# UNITED STATES PATENT AND TRADEMARK OFFICE

APPLICATION NO.	FILING DATE	FIRST NAMED INVENTOR	ATTORNEY DOCKET NO.	CONFIRMATION NO.
10/762,992	01/22/2004	Mark Zieff	30394-101	5992

**Office Action Summary**

## **DETAILED ACTION**

Fig. 5

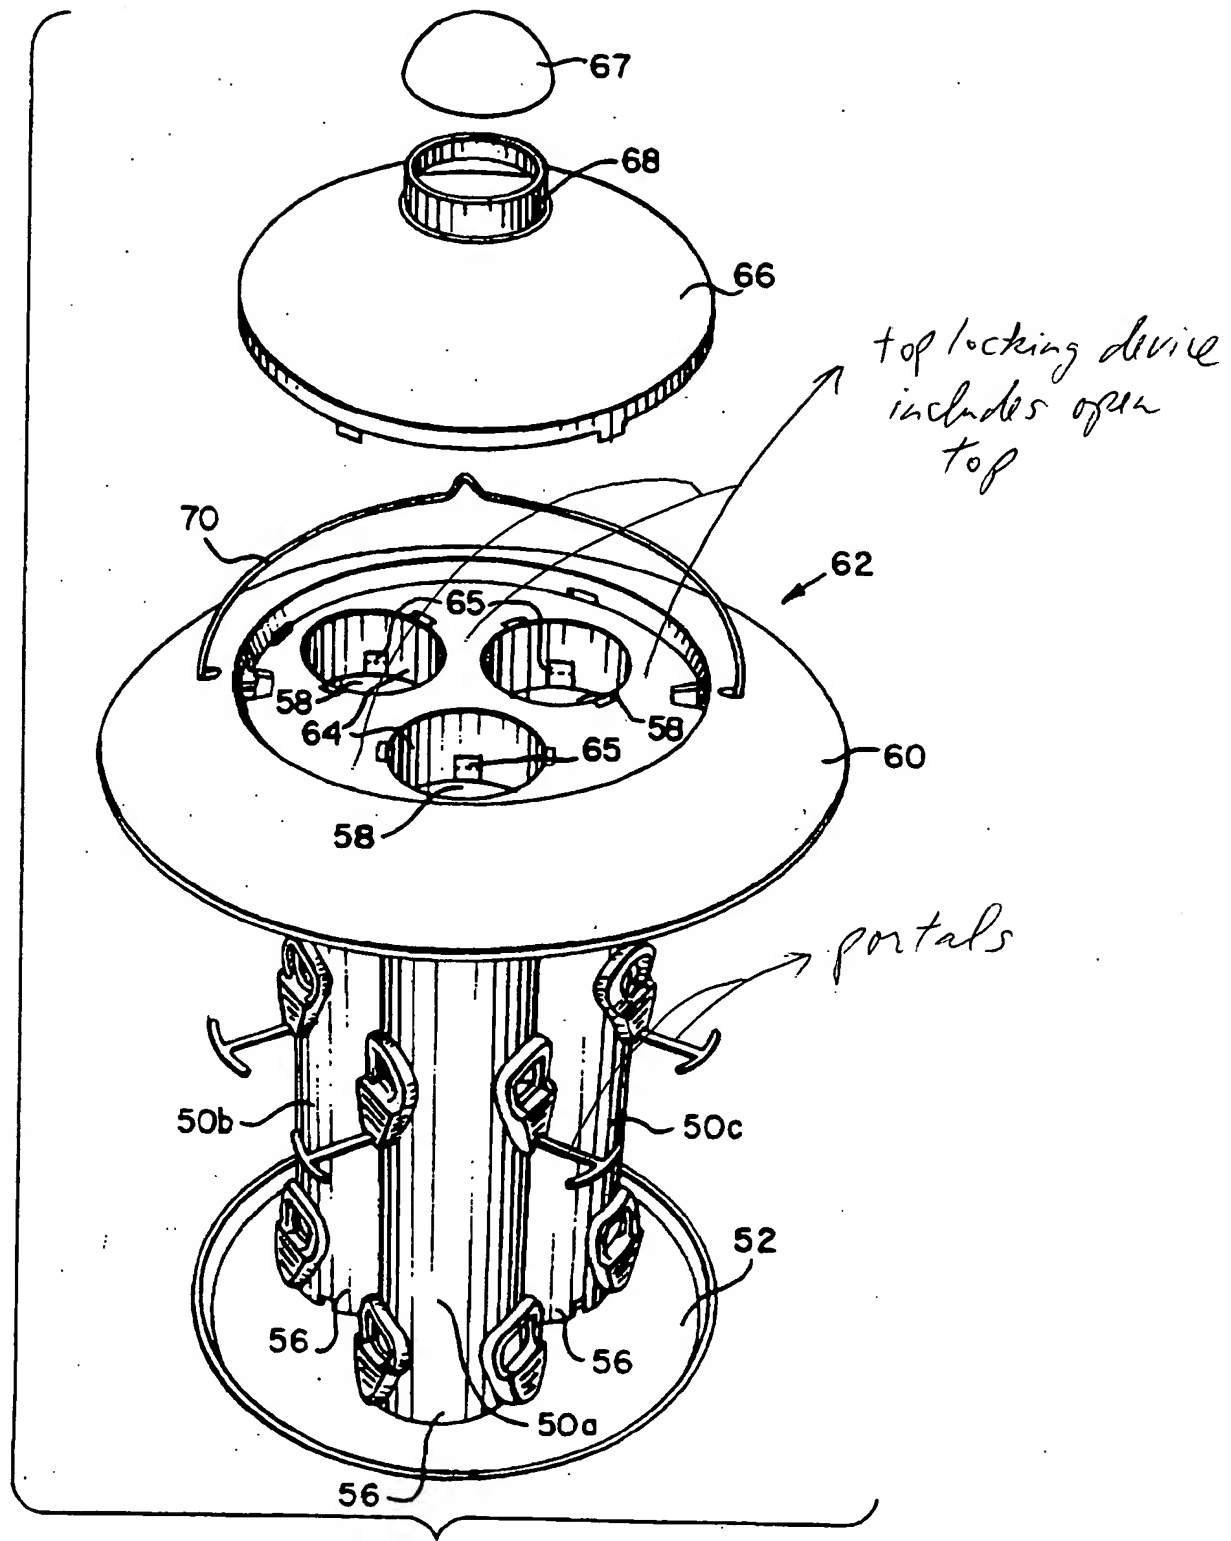
(c) a top locking device (see Figure 5 attached at the end of this Office Action), wherein a top end of said one of more feeding chambers opposite to said base being securely disposed within said top locking device, said top lock device includes a open top to access said top end of said one or more feeding chambers; and

For claim 4, Walter et al. disclose said one or more feeding chambers further comprise one or more portals (see Figure 5 attached at the end of this Office Action).
